**TOWN OF BAY HARBOR ISLANDS  
MORRIS N. BROAD COMMUNITY CENTER  
1175 95TH STREET  
BAY HARBOR ISLANDS, FL 33154**

**DEVELOPMENT & REVIEW COMMITTEE MEETING**

**TOWN OF BAY HARBOR ISLANDS  
COMMUNITY DEVELOPMENT  
MEMORANDUM**

**Subject:** Site Development Plan Application (4<sup>th</sup> DRC Review)  
1085 Townhouses – 6 DU Townhouse Complex  
1085 94<sup>th</sup> Street  
Bay Harbor Islands Acct. No. SPR24-000025  
MMPA Account No. 01-0702-1197

**FIRST FLOOR PLAN**

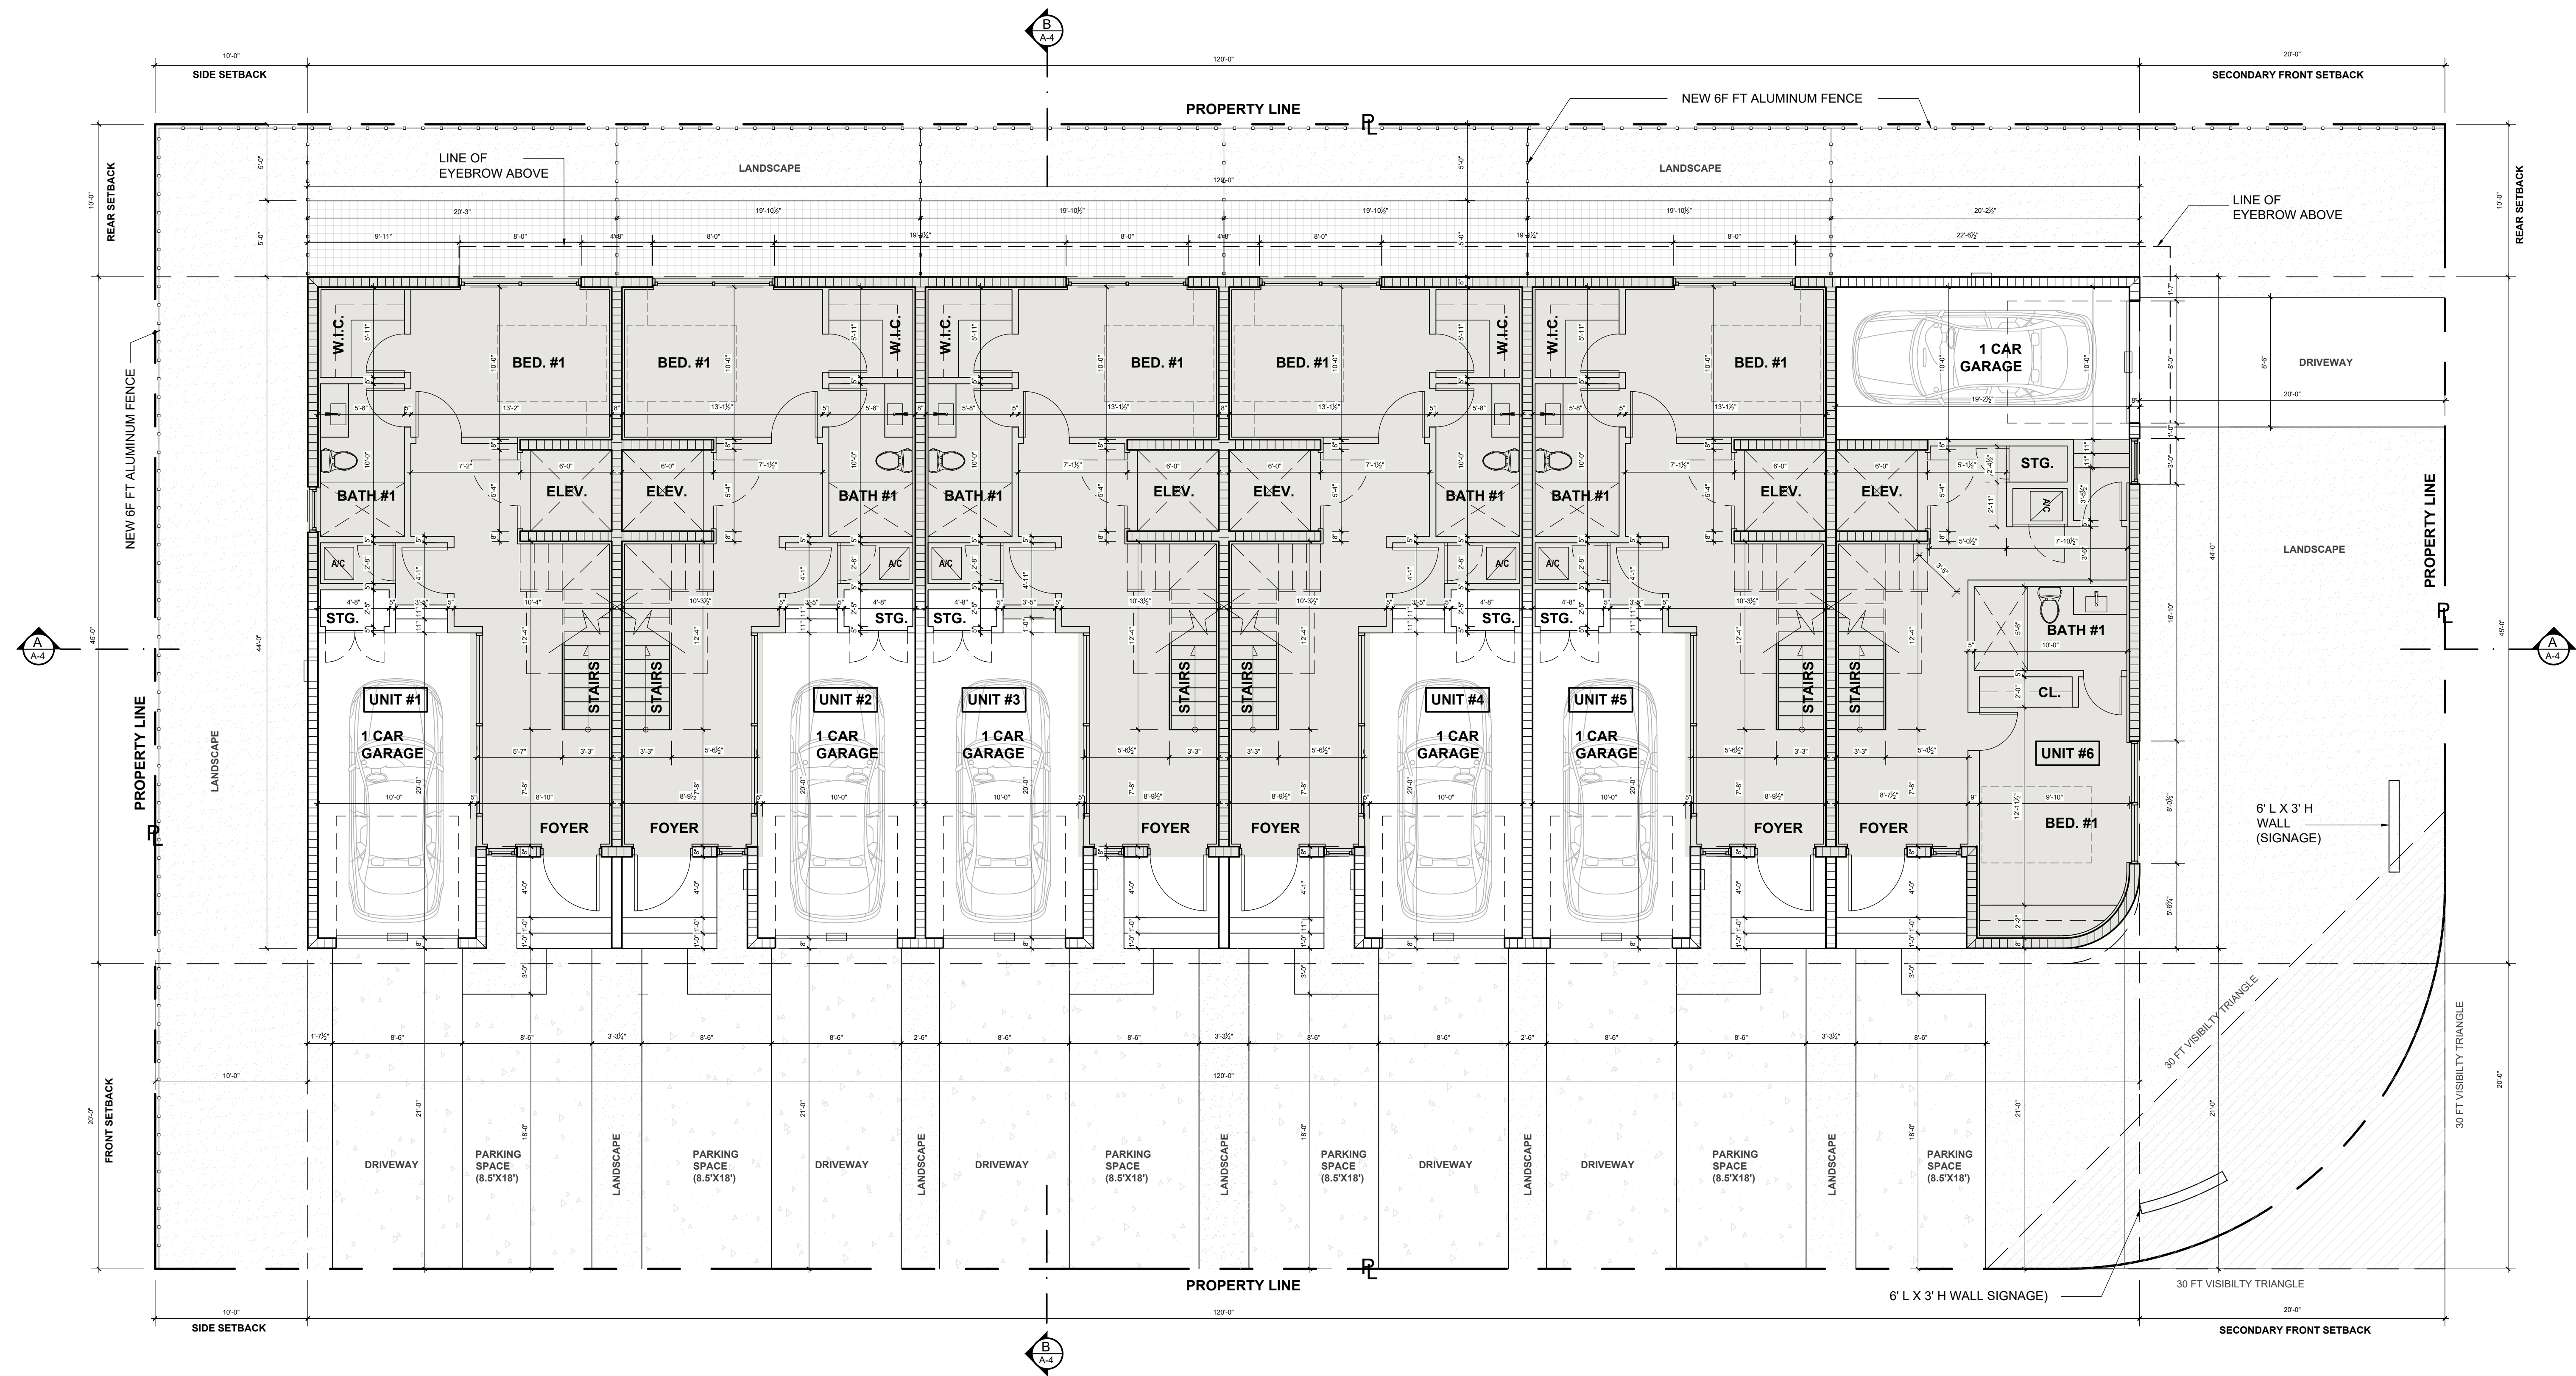
- 4) The proposed driveway design for the DU adjoining 94<sup>th</sup> Street, in an attempt to comply with the Town's 30' visibility setback at comers, is inconsistent from sheet to sheet (Sheet A-2 appears to show it encroaching).

Driveway configuration for corner unit changed. No driveway encroaching any visibility triangle. Please refer to sheet A-1 and A-2 for new drawings.

# PHOTOMETRIC REPORT

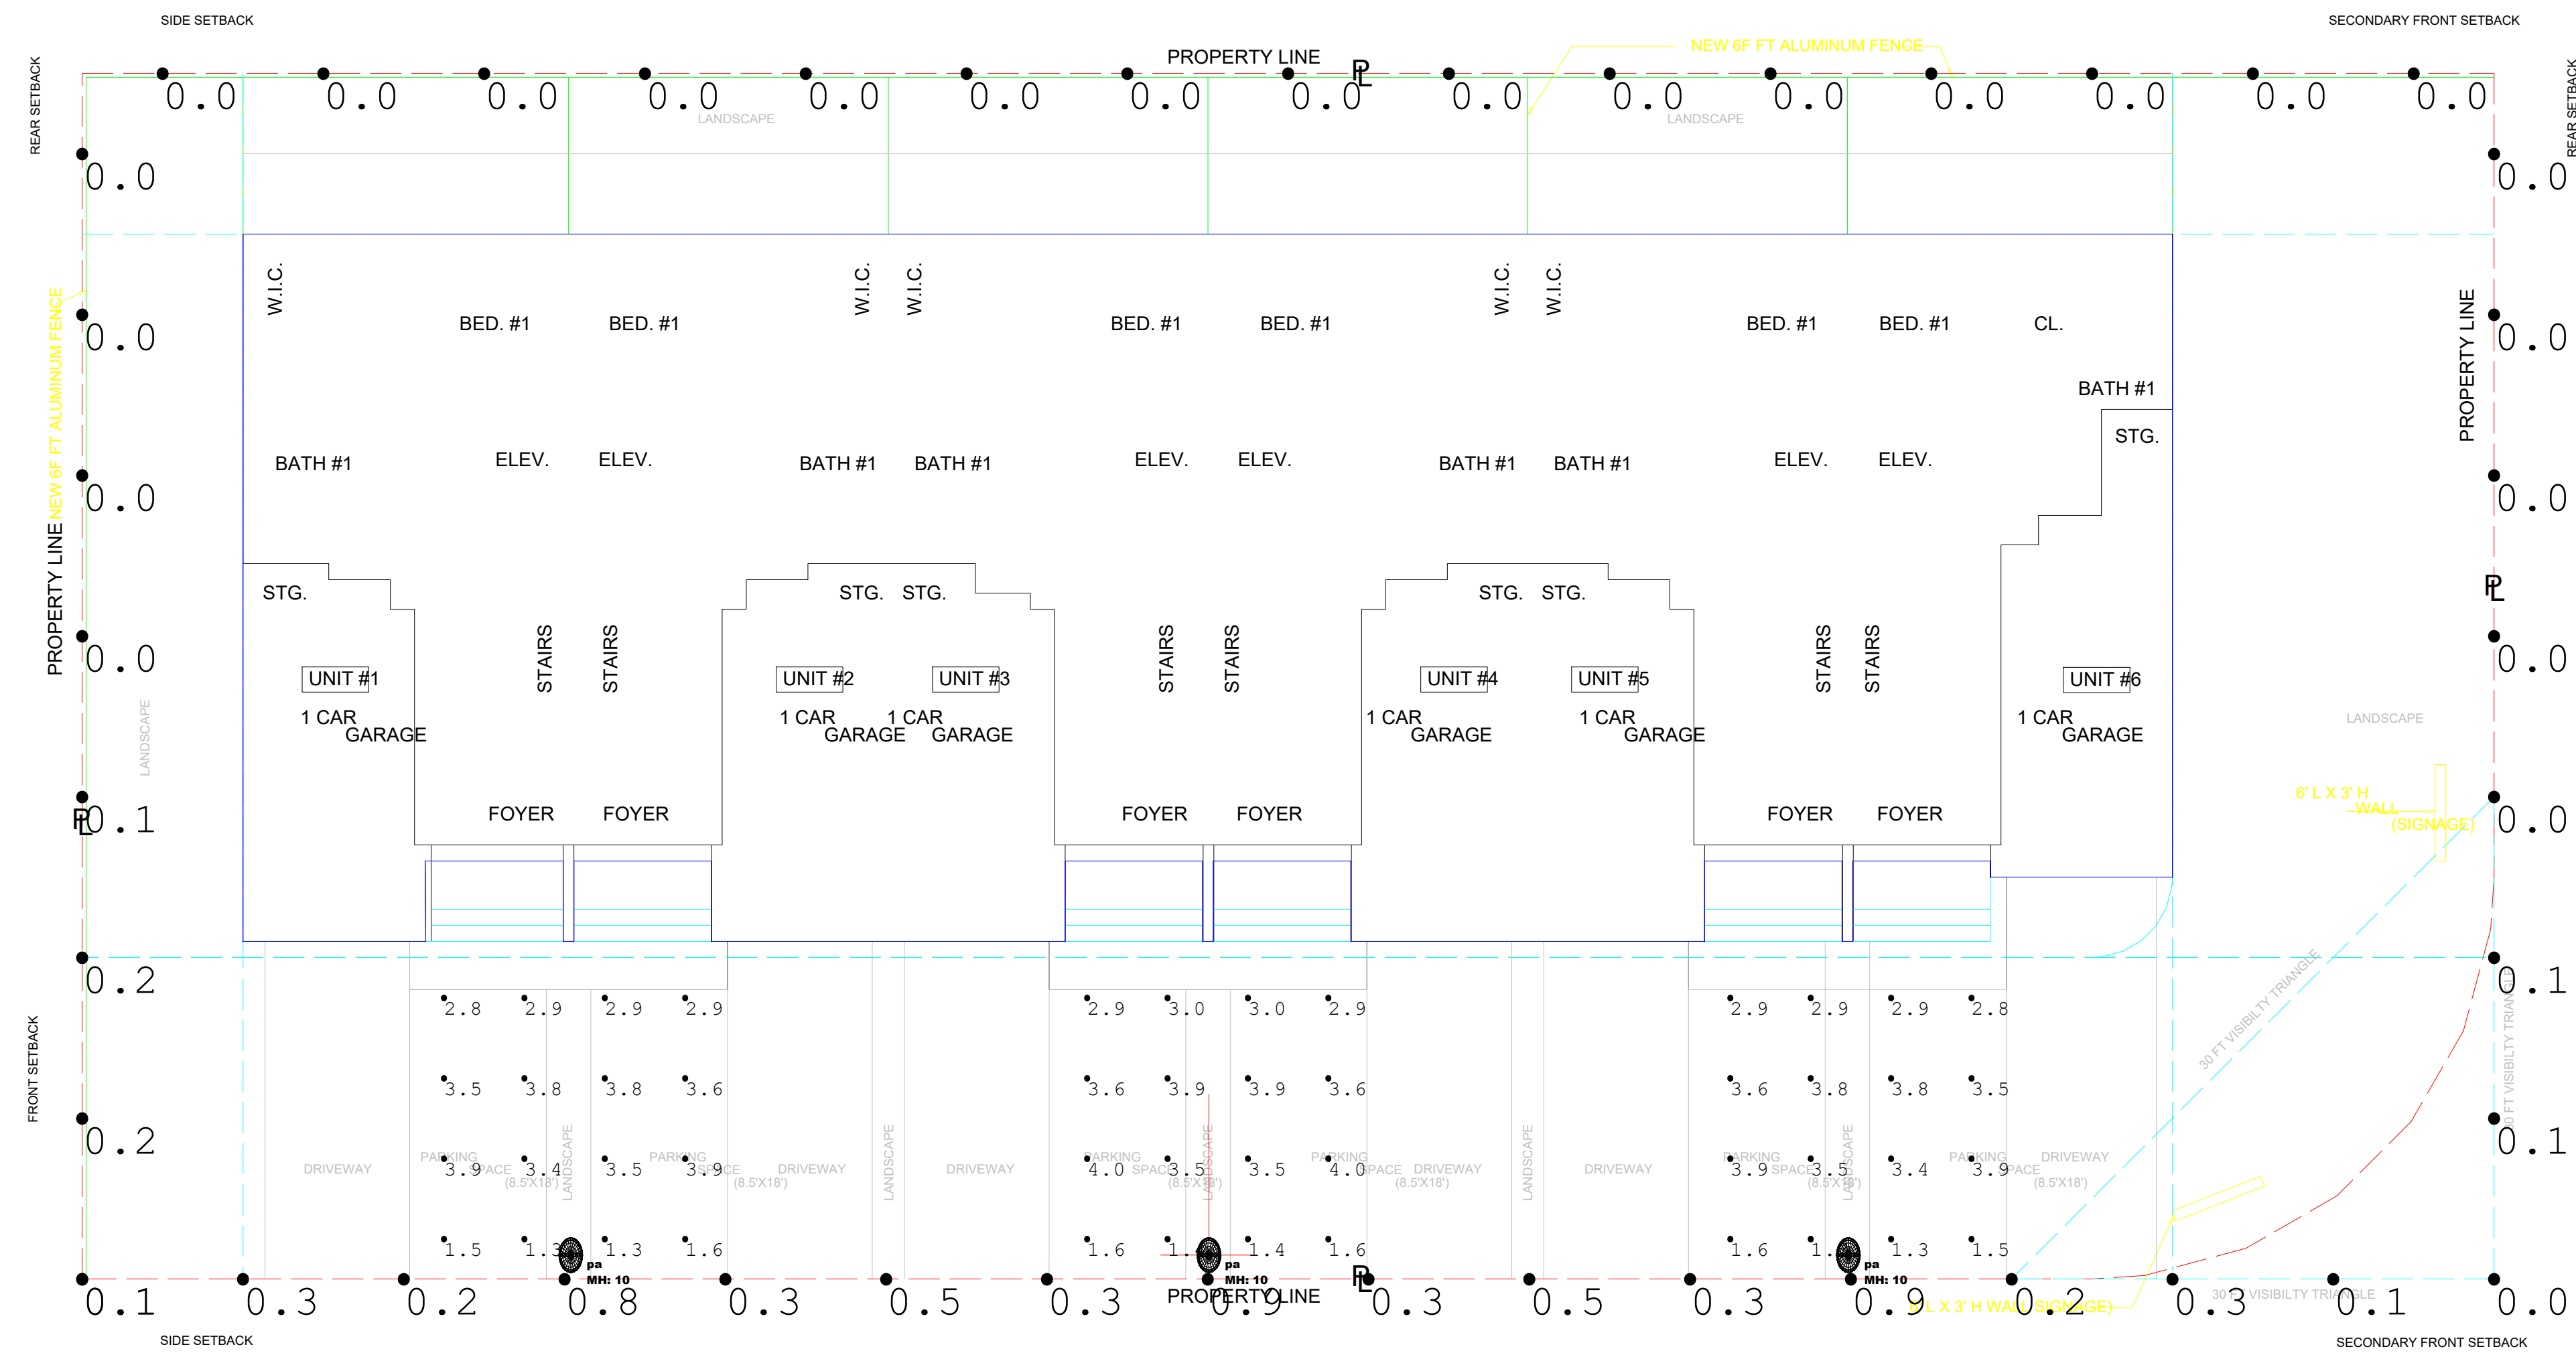
- 2) Per Sec. 23-19 a preliminary Photometric Plan must be submitted showing foot-candle readings at all property lines and on the rooftop. The r submittal package now includes a preliminary plan. Again, the maximum foot-candle reading allowed at any property line in 1.0; however, the plans show several locations where th 1.0 is exceeded. Revise.

New Photometric Plan showing foot-candle less than 1.0 provided as requested.  
Please refer to Photometric drawings.

**C-2**

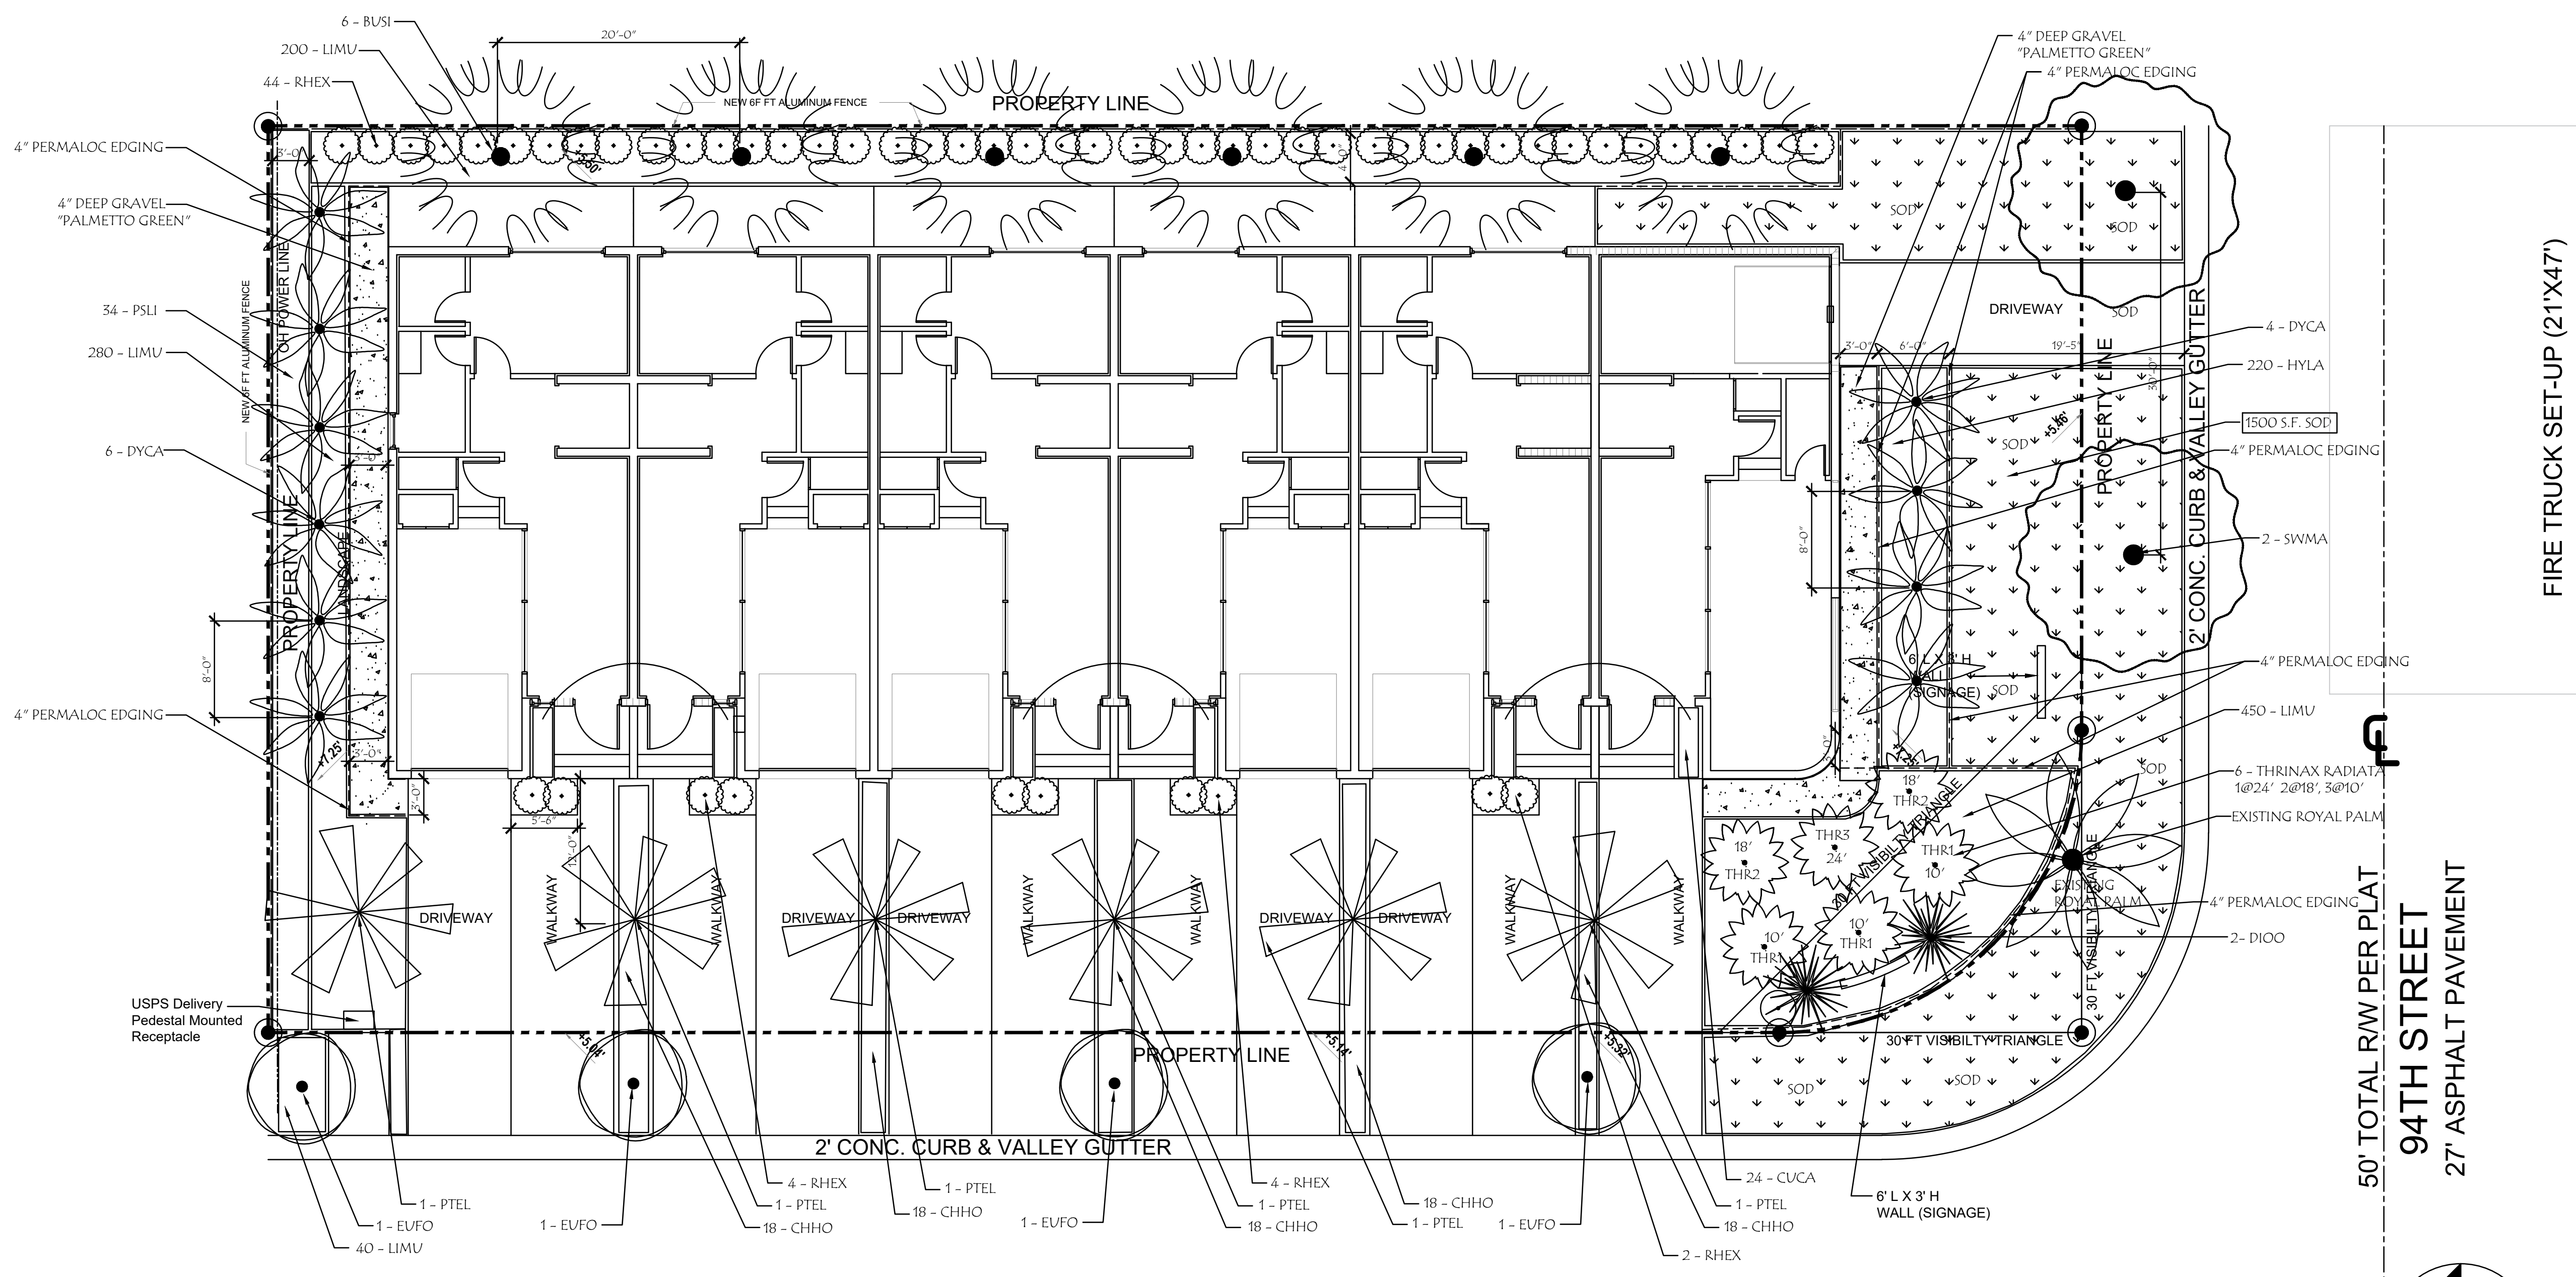
2. Show details of fire line Et..All..  
**Response: Refer to Sht. C-2 of the project submitted of the working drawings.**
